# **Norwich Western Link**

## **Design and Access Statement – Appendix A**

**A10 WEST WINCH HOUSING ACCESS ROAD**

**STAGE 1 SAFETY AUDIT**

**6.0 Problem Location Plans**

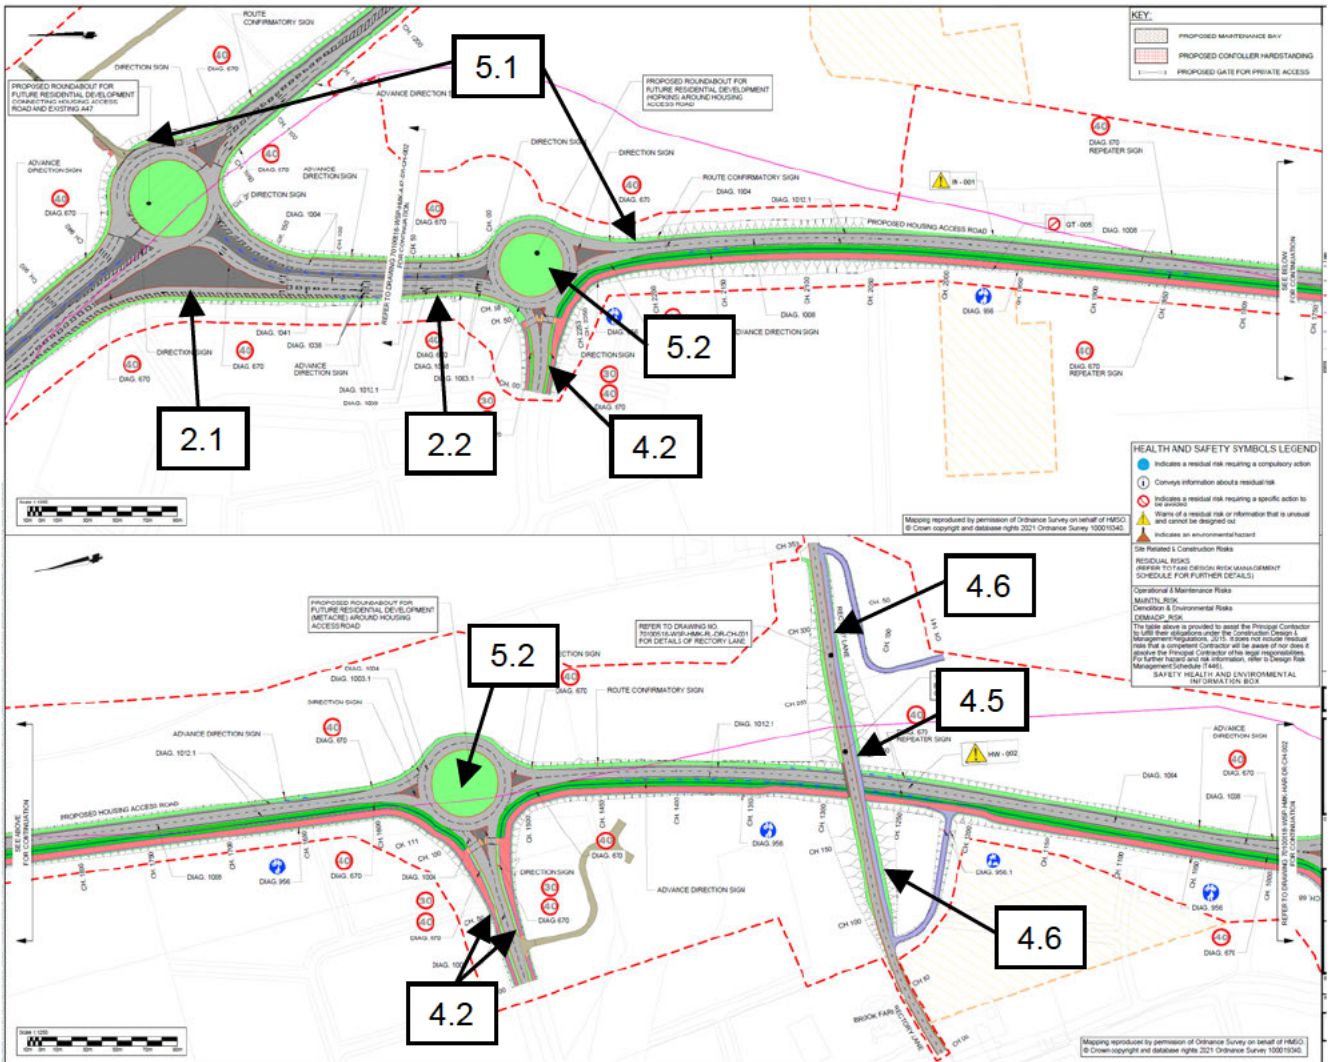
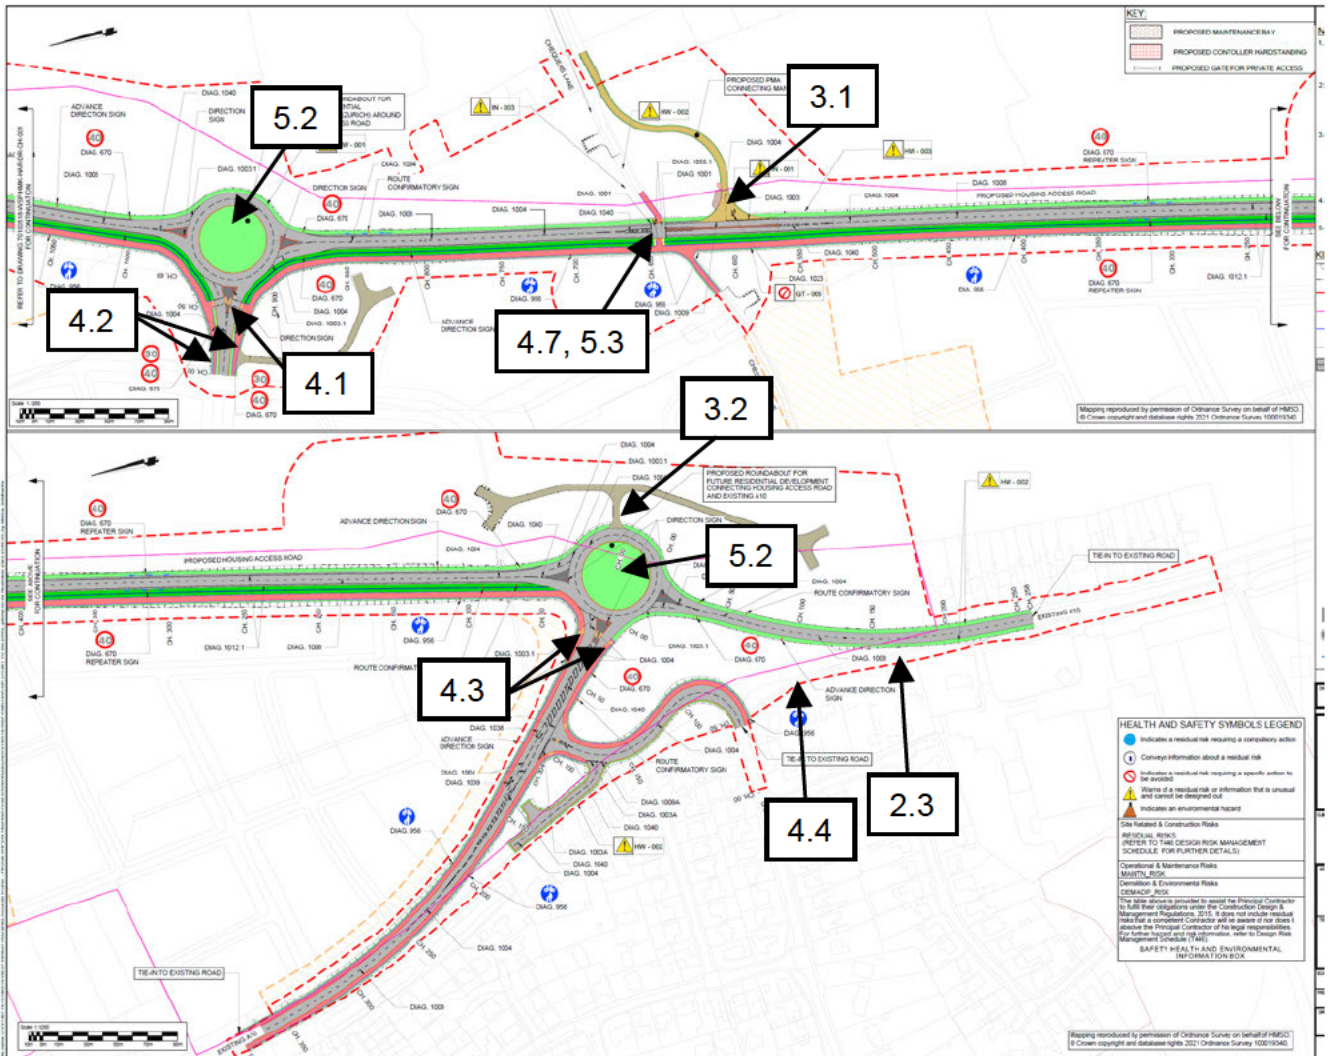
It is understood that a 70kph (40mph) design speed and speed limit have been adopted for the link road. The link road has predominantly straight alignment, albeit broken up by several roundabouts. Furthermore the highway cross section is wide – 7.3m carriageway, 1m hard strips, 5.0m wide swale and 4.0m shared use. With no obvious developed frontage, the audit team is concerned that speed limit compliance will be poor. There may also be marked speed differential between compliant and non-speed limit compliant drivers. Hence, there is an increased risk of speed related collisions (e.g. overtake, tail end collision). Of particular concern are the long uninterrupted lengths of link road south of the Hopkins roundabout.

VRS is proposed extensively throughout the access road to protect roadside hazards. In several instances, this appears appropriate (e.g. at bridge piers), however, there are also situations where VRS is used at point hazards (e.g. speed limit repeater signs, advance directions signs). Whilst roadside hazards should be mitigated, VRS represents a collision hazard in itself and may not be the best solution for all point hazards. Long lengths of VRS also gives an over-engineered appearance at odds with a 40mph design speed (see also 1.1).

Landscaping plans indicate new tree planting in areas where vehicles carry a risk of leaving the carriageway. Vehicle collisions with mature trees carry a high risk of serious or fatal injury for vehicle occupants. Of particular concern are roundabout central islands, the segregated left turn island at A47, and trees at roundabout exits.

No details have been provided regarding detailed roundabout geometry. Of particular concern is lack of detail for entry path curvature which is a key determinant of roundabout safety as it directly affects the entry and circulatory speed for a roundabout. However, other geometric features such as entry and exit kerb radii, circulatory width and landscaping can also influence the safe operation of a roundabout.

1.1, 1.2, 1.3, 2.4 – Throughout the housing access road

Recommendation – it is recommended that the highway cross section is reduced to a lower standard more in line with a 70kph design speed and/or speed management measures introduced.

Recommendation – Where possible, it is recommended that single point hazards (e.g. traffic sign posts) are specified as passively safe as an alternative to long lengths of VRS.

Recommendation – It is recommended that any trees which have the potential for a trunk girth greater than 250mm are not planted in the above high risk areas. Roadside trees on links to be set back at least 4.5m from the carriageway edge.

Recommendation – It is recommended that roundabout geometry is subject to safety audit prior to detailed design.
